UNITED STATES PATENT AND TRADEMARK OFFICE

| APPLICATION NO. | FILING DATE | FIRST NAMED INVENTOR | ATTORNEY DOCKET NO. | CONFIRMATION NO. |
|-----------------|-------------|----------------------|---------------------|------------------|
| 10/810,510 | 03/26/2004 | Fan Ho | 24295/81401 | 1180 |

| Office Action Summary | Application No. | Applicant(s) | |

FIG. 3

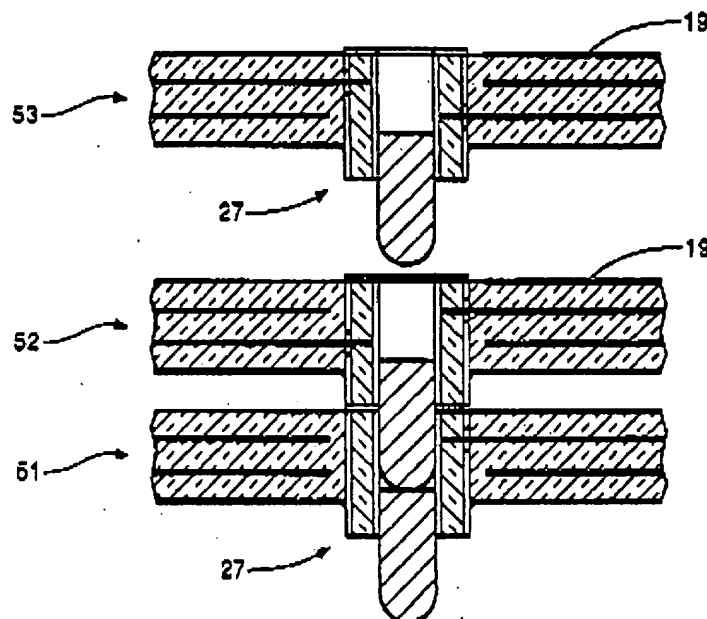
23. Applicant's arguments filed 12/29/2006 have been fully considered but they are not persuasive. Applicant argues that Kledzik does not disclose a second ground. As shown in figure 3, is a schematic depiction of a stack of packages 51-53. Although not labeled the substrate 53-51 include the basic limitation of package 21 thus the bottom layer of 53-51 correspond to the ground layer 33 depicted in figure 2. Kledzik teaches in col. 5/lls. 56-60, "*In some cases, additional layers of circuit traces 31, 32, and 33 may be incorporated into or below the substrate 17, in the configuration of a multilevel printed circuit board. In many cases, one layer, such as layer 33, is configured as a*

ground plane. In this manner, the module 11 can be constructed with a controlled electrical impedance, as determined by various factors". In this case, any layer connected to the layer 33 in the same substrate or in other substrate is recognized as ground plane because is connected to the ground.
